# ROCKY FLATS SITE

## REGULATORY CONTACT RECORD

**Purpose:** Soil Disturbance Review Plan—Roads maintenance, including grading the road to the former A-3 Pond to convert the road to two-track vehicle use.

**Proposed Project:** Roads maintenance, including grading the road to the former A-3 Pond to convert the road to two-track vehicle use.

Figure 1. Road Maintenance Locations

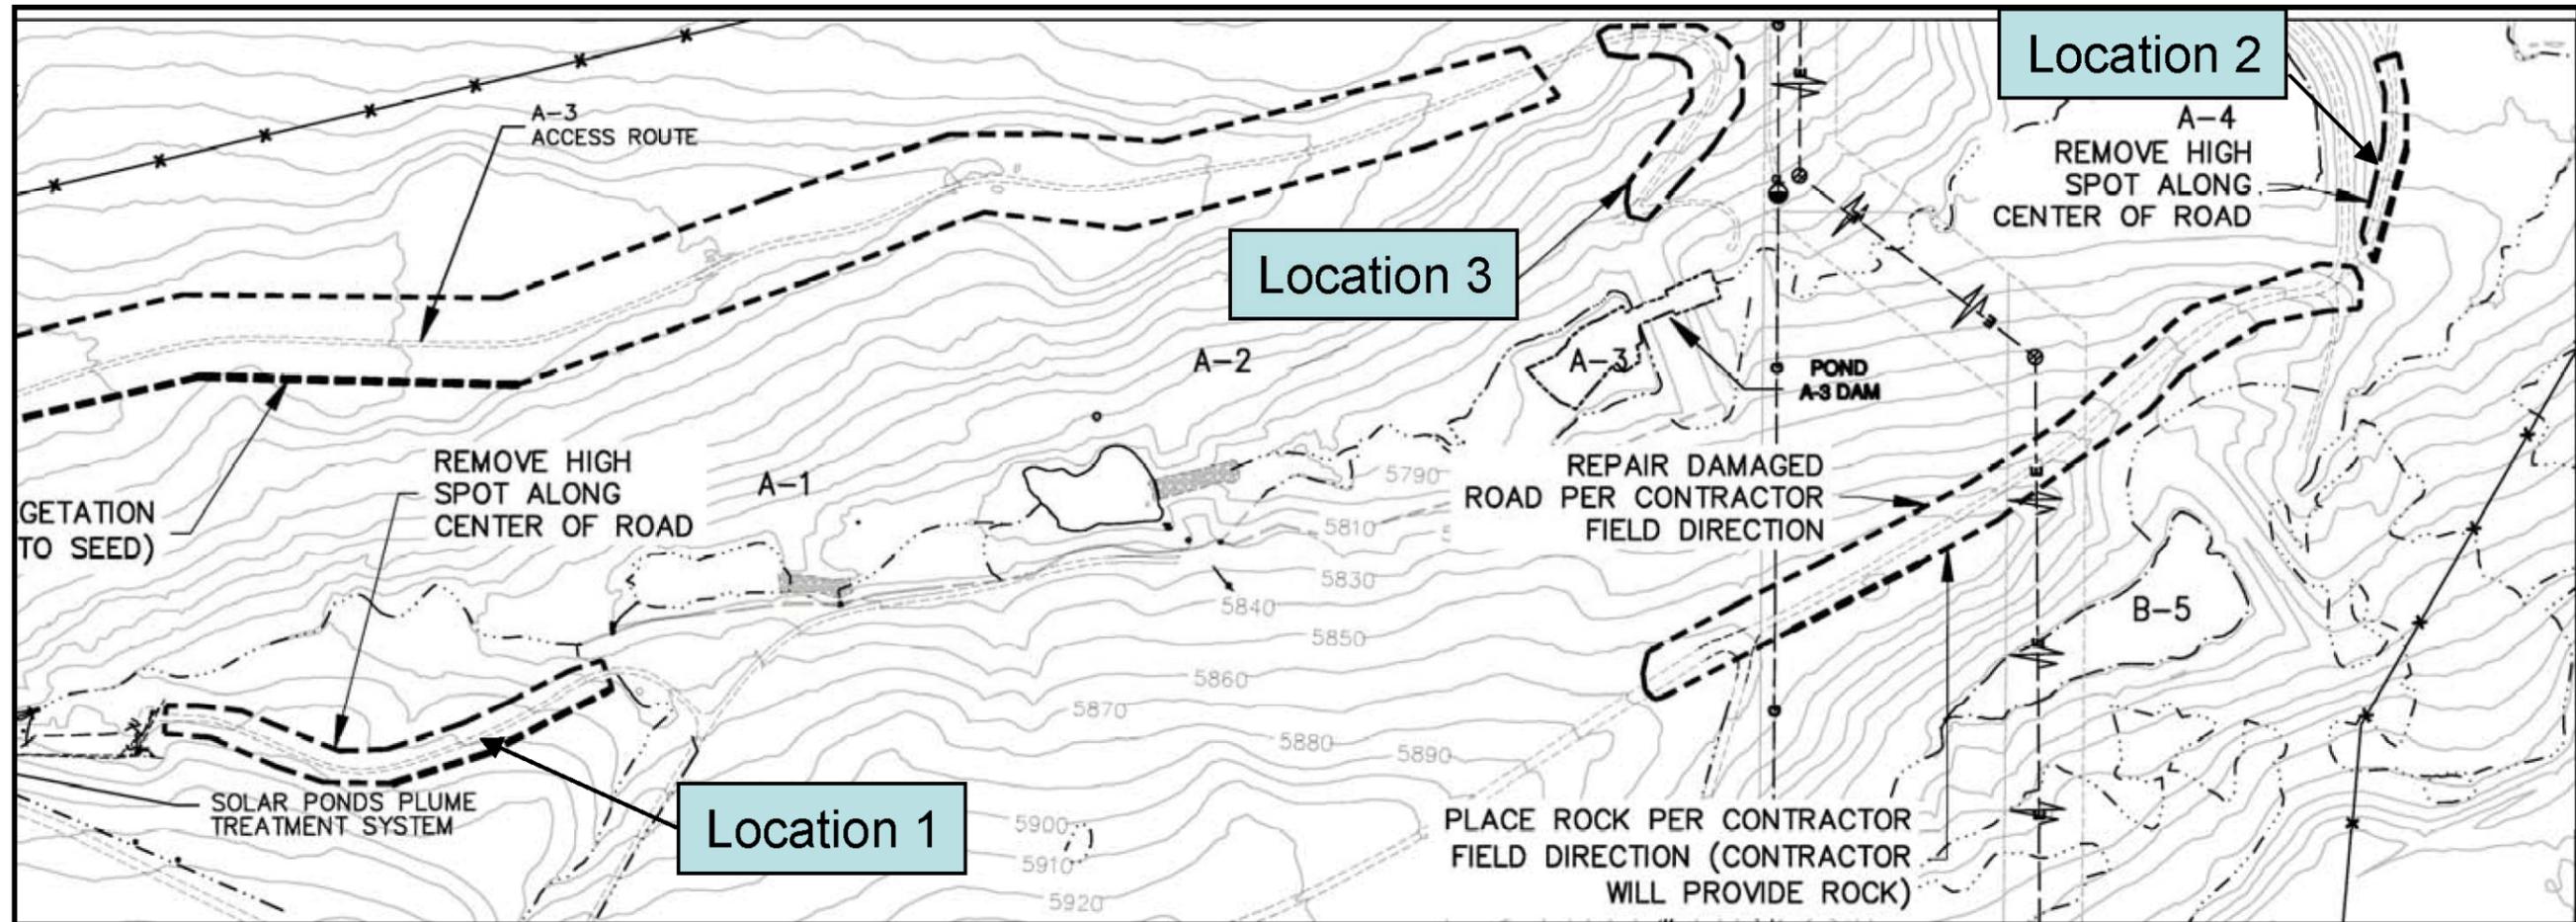
CDPHE has reviewed information regarding the proposed soil disturbance and excavation and, after consultation with EPA, CDPHE has approved the proposed activity. CDPHE has determined that the proposed activity will not result in an unacceptable release or exposure to residual subsurface contamination, and will not damage any component of the remedy. CDPHE has also determined that the proposed project meets the rationale and objectives of IC 2 and IC 3.

For clarity in this Soil Disturbance Review Plan, the areas under discussion are identified on Figure 1 as Locations 1 and 2 (gravel road sections where centerline humps will be removed) and Location 3 (a gravel road that will be regraded and revegetated for two-track vehicle use). The locations are as follows:

**Resolution:** Carl Spreng, CDPHE, approved the soil disturbance and excavation work described in the Soil Disturbance Review Plan (Attachment 1).

Figure 2. Road to Former Pond A-3

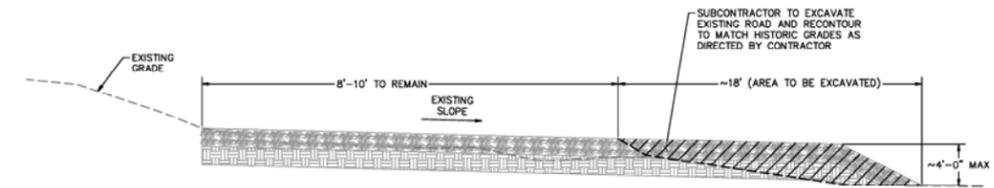
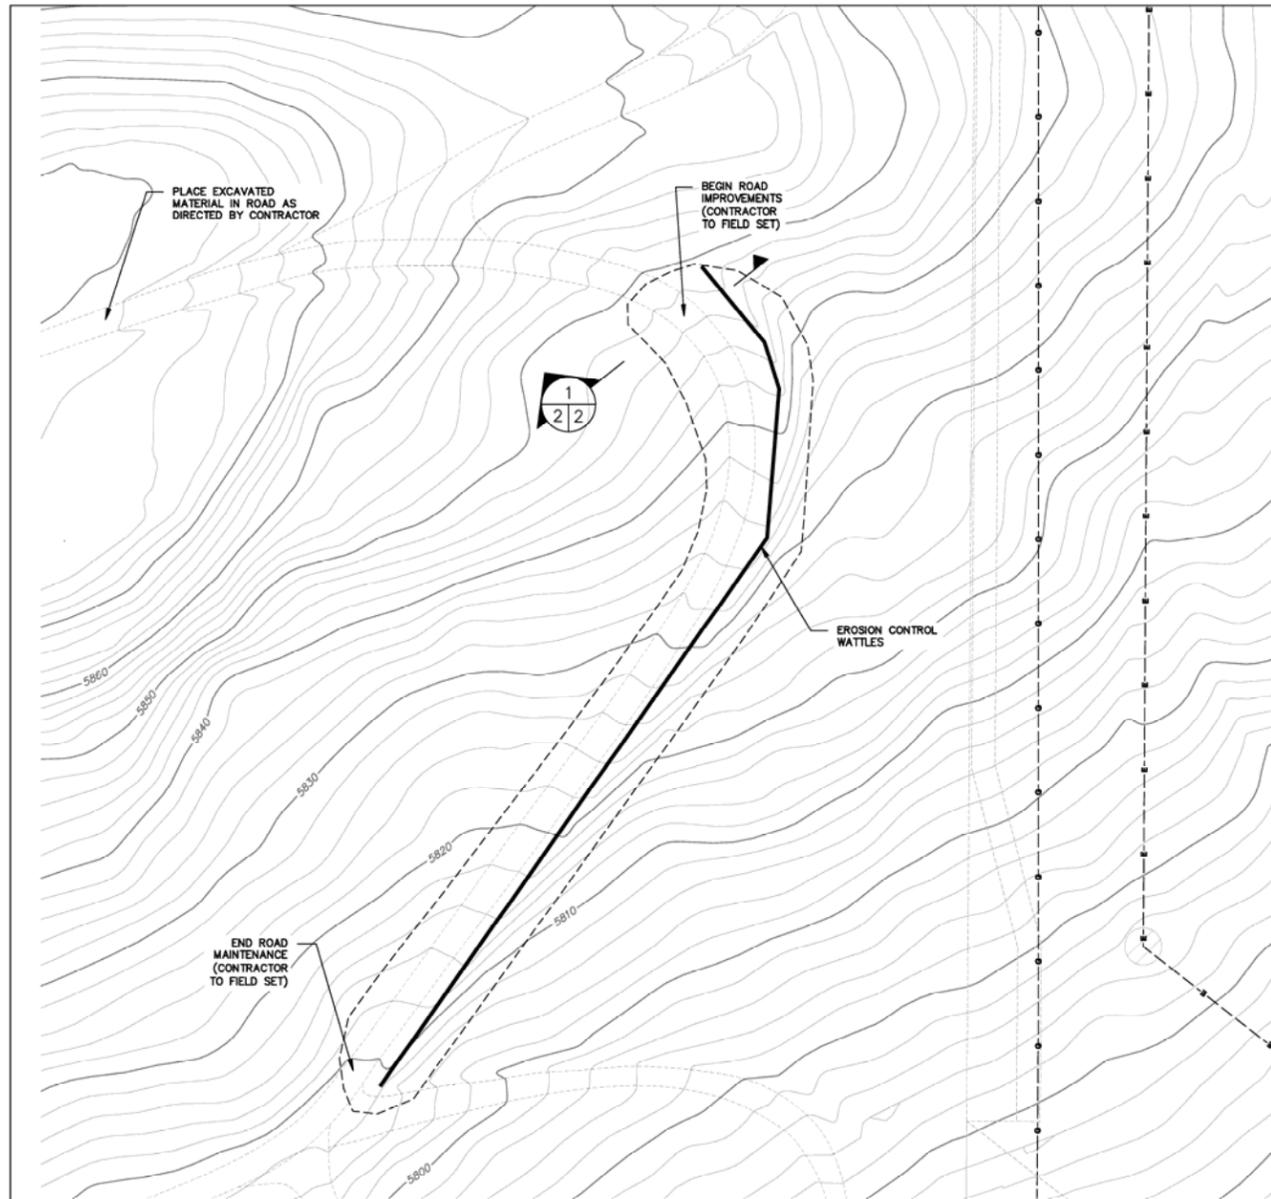
The purpose of the project is to perform routine maintenance of gravel roads and to revegetate and regrade a section of existing gravel road to convert it to two-track vehicle use. The work locations are shown in Figures 1 and 2. The maintenance will include removing approximately 6 inches of soil that form the centerline humps in the gravel roads at Locations 1 and 2 that could pose a vehicle safety hazard if not removed, and grading the removed material into the low spots adjacent to the humps. The gravel road in Location 3 was previously graded to accommodate truck use. One portion, on a hillside, has a horizontal “bench” profile that entails precipitation runoff and erosion control maintenance requirements. The removed soils will be placed and graded within the gravel road footprint. Regrading to remove the “bench” profile and revegetation will accommodate two-track vehicle use and improve the runoff characteristics in this area, thus minimizing the erosion potential and the need for erosion controls when the vegetation is established.

NOTE:  
EXCAVATE SPOILS TO SUBGRADE AND  
SPREAD OVER EXISTING ROAD AS  
DIRECTED BY CONTRACTOR
